N1092C-03

Information Only Service Note

N1092C DCA-M Sampling Oscilloscope

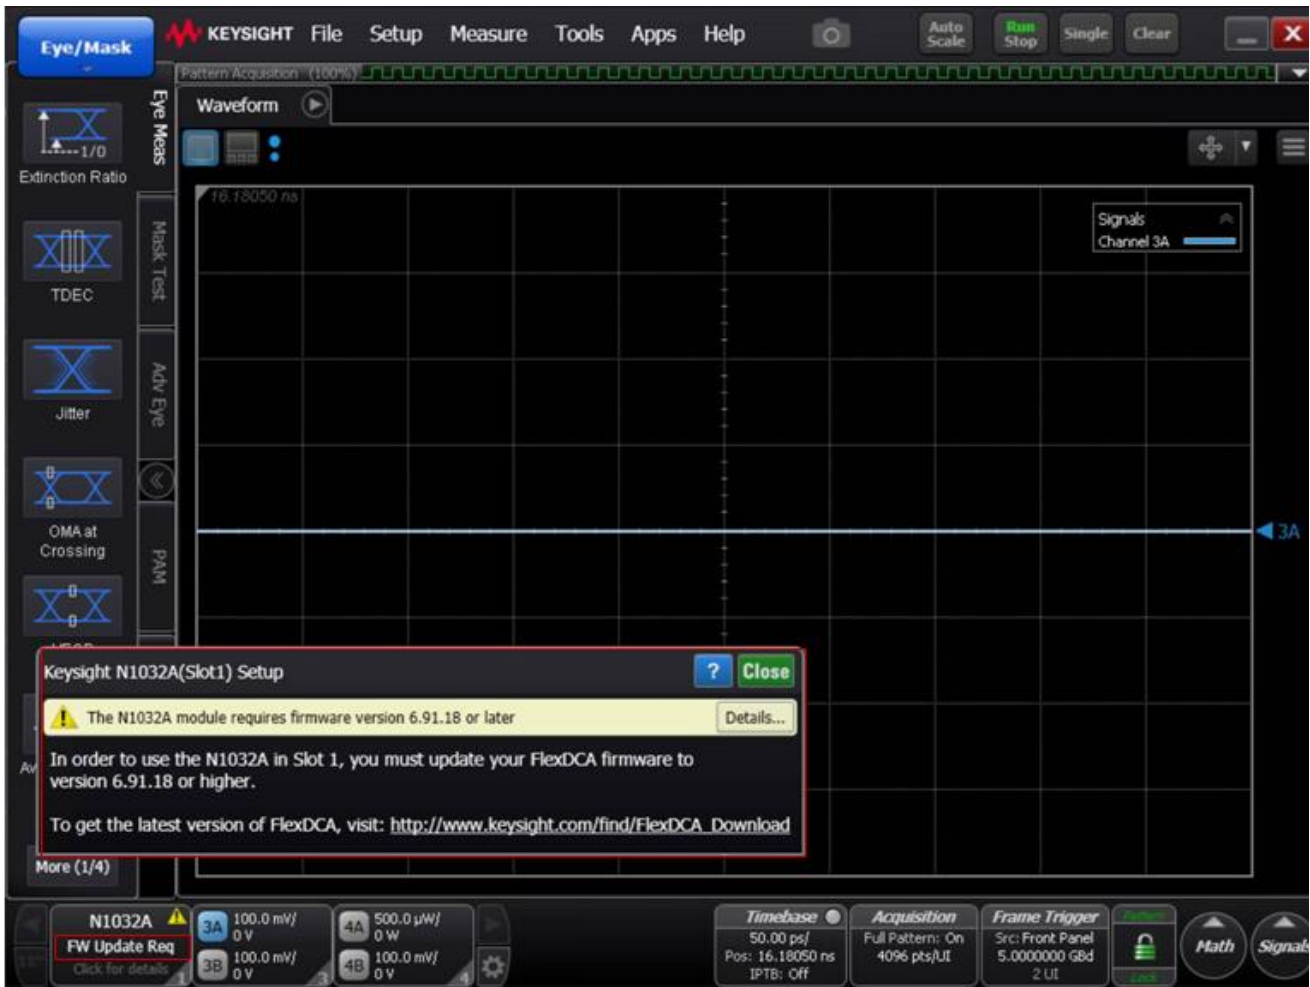
With the instrument connected to FlexDCA, if a message like the one below is displayed, FlexDCA must be updated to the indicated version (or later):

To update FlexDCA software, download from www.keysight.com/find/flexdca_download and install. While only the indicated version is required, updating to the latest version is recommended.
